TULSA METROPOLITAN AREA PLANNING COMMISSION

April 4, 2007

PRELIMINARY SUBDIVISION PLAT

Woodland Hills Courtyard by Marriott - (8301) (PD 18) (CD 7)
West of the northwest corner of South Mingo and East 71st Street South

OVERLAND PARK II

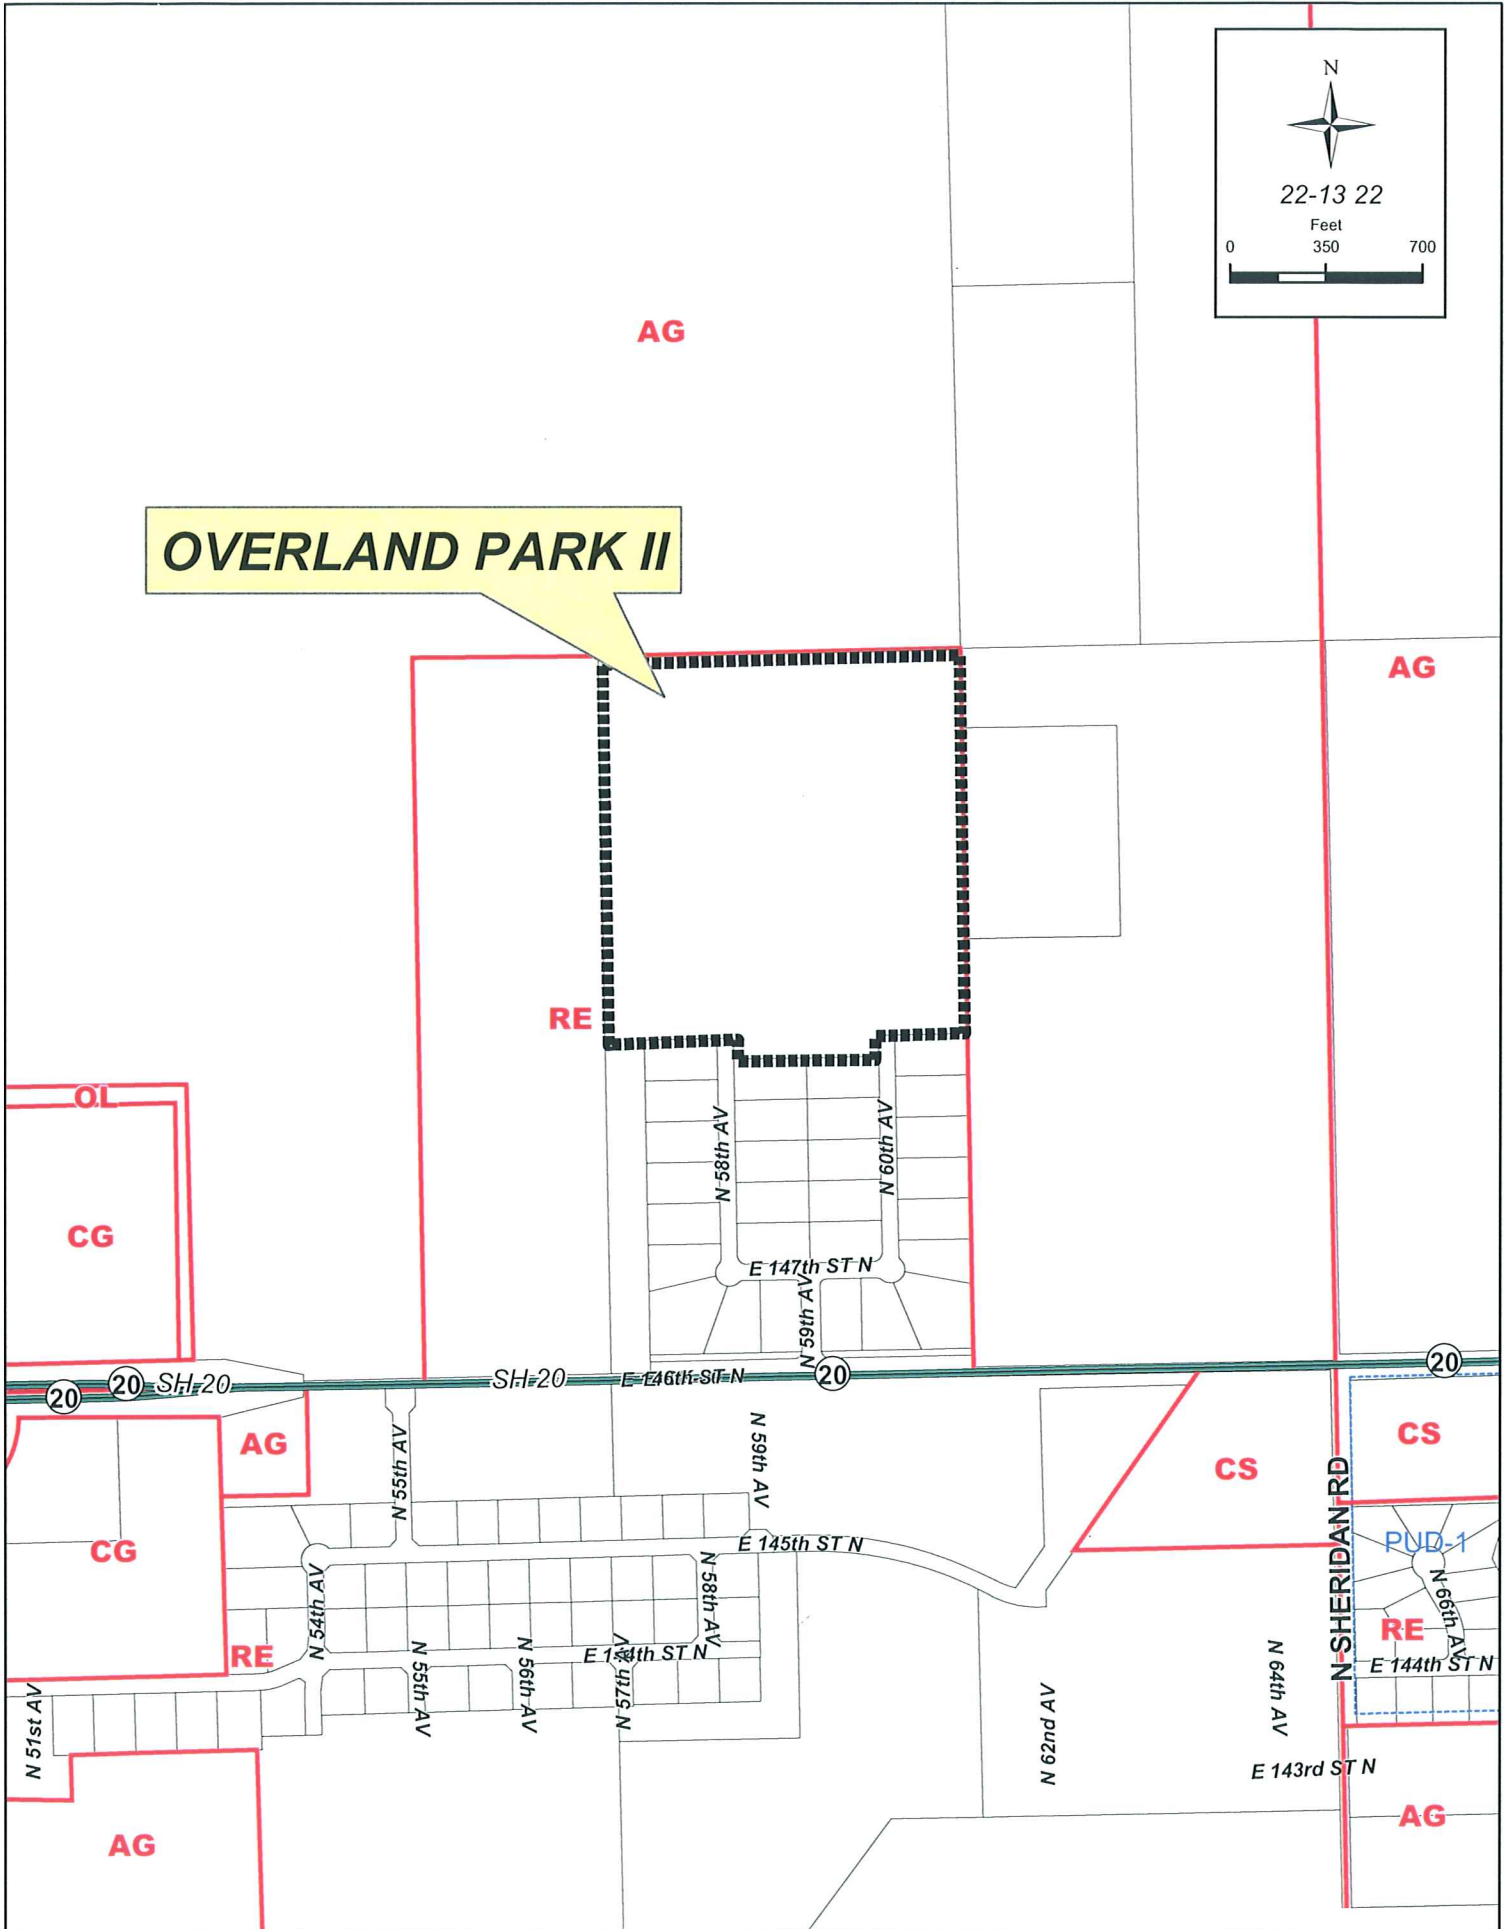
1. **Zoning:** The property is zoned RE . The cul-de-sac may be too long with this next phase of development and a waiver will be necessary unless there is a stub street used at the north part of the plat. The County Engineer and Planning staff will work with the developer on the stub street locations. Keep floodplain on plat.

2. **Streets:** No comment.

3. **Sewer:** No comment. Septic systems are proposed.

7. **Other: Fire:** A release letter from the Fire Department serving the subdivision will be required. **GIS:** Complete key/location map. Show "Basis of Bearing." Move plat name and legal description to top of plat. In Covenants move "legal description" up above Article F. Place Covenants on a second page (too small). **County Engineer:** Flood plain along north side needs to be defined as drainage easement to restrict building. Need language regarding the detention pond – possibly place it in a reserve area – to be maintained by Homeowners' Association. For future circulation and a future second point of access, need stub streets to the east and west. Street names and addresses will be provided by E-911.

ONG Addition, Tulsa County
Minor Subdivision Plat, March 14, 2007
SHEET 1 OF 2

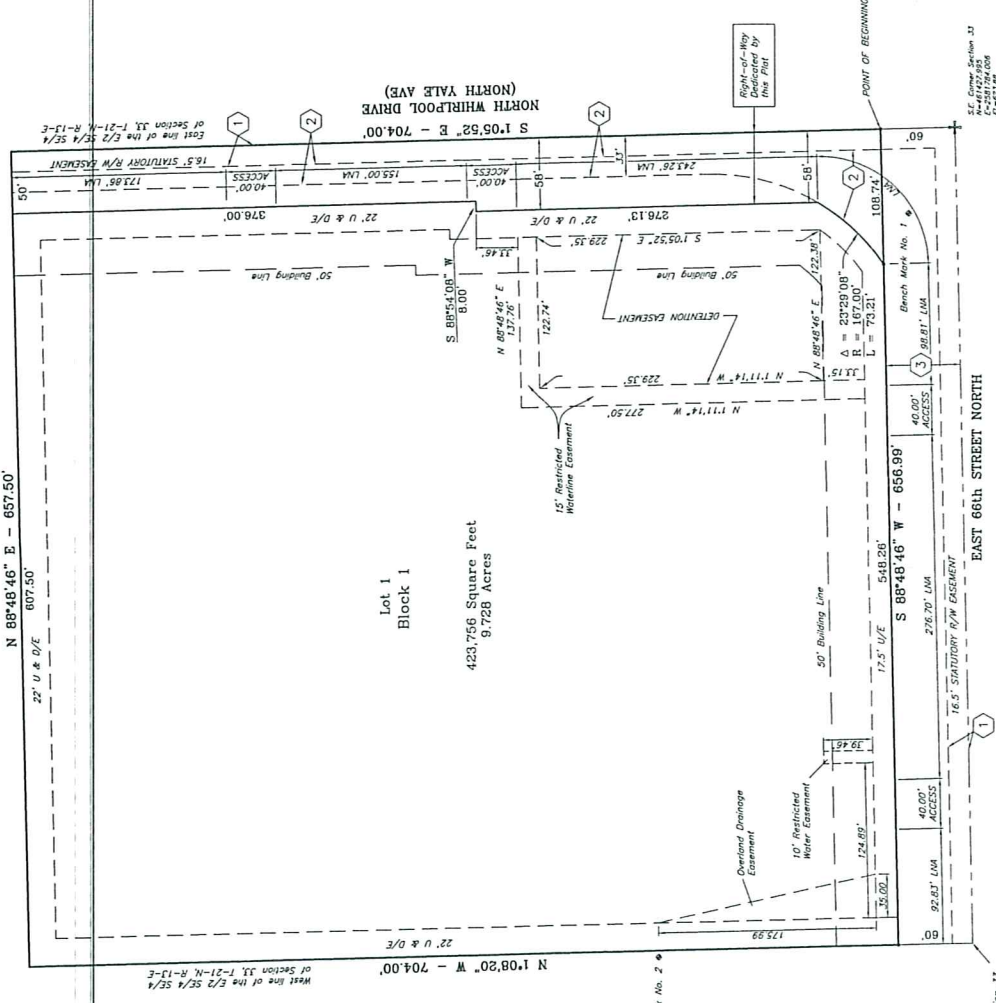
2. **Streets:** Change the access points along Yale from 60 feet to 40 feet to be consistent with the site plan. Dimension the right-of-way along 66th Street North just west of the point of beginning.

4. **Water:** Add standard language for the restricted water line easement.
